NAC-MPC

NAC Multi-Purpose Cask

MPC-LACBWR Technical Specification Changes

Subject: Submission of a Request to Amend the U.S. Nuclear Regulatory Commission Certificate of Compliance No. 1025 for the NAC-MPC® Cask System

A 3.1.6 CONCRETE CASK Heat Removal System

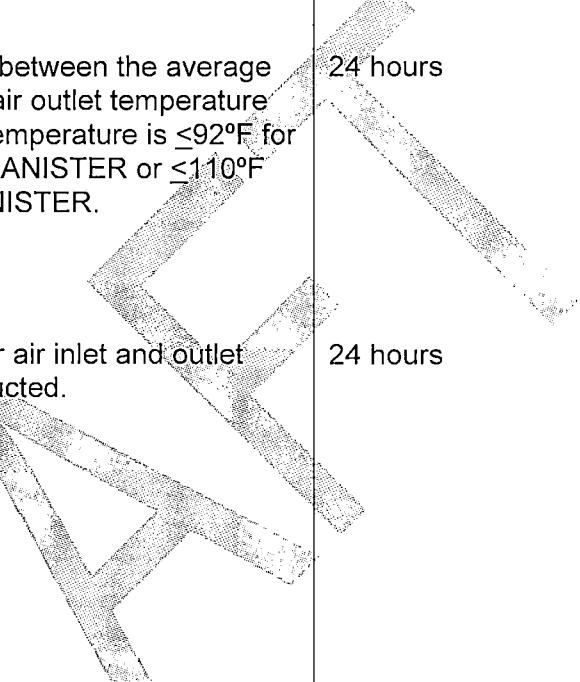
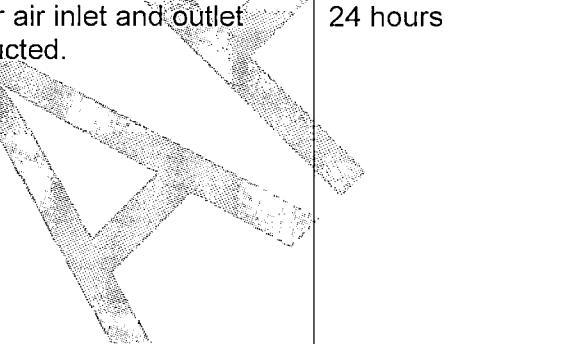
Separate Condition entry is allowed for each NAC-MPC SYSTEM. LCO 3.1.6 is not applicable to the MPC-LACBWR CANISTER.

SURVEILLANCE REQUIREMENTS

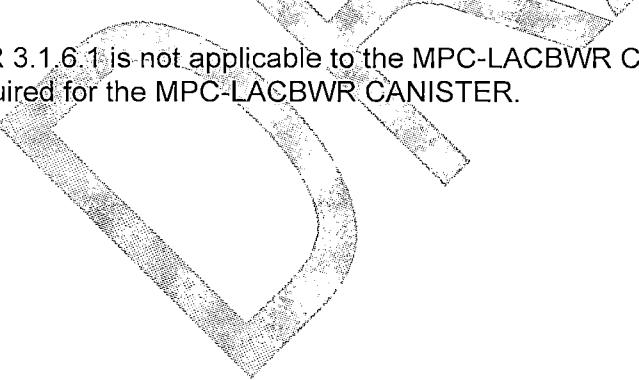
¹ SR 3.1.6.1 is not applicable to the MPC-LACBWR CANISTER. Convective cooling is not required for the MPC-LACBWR CANISTER.
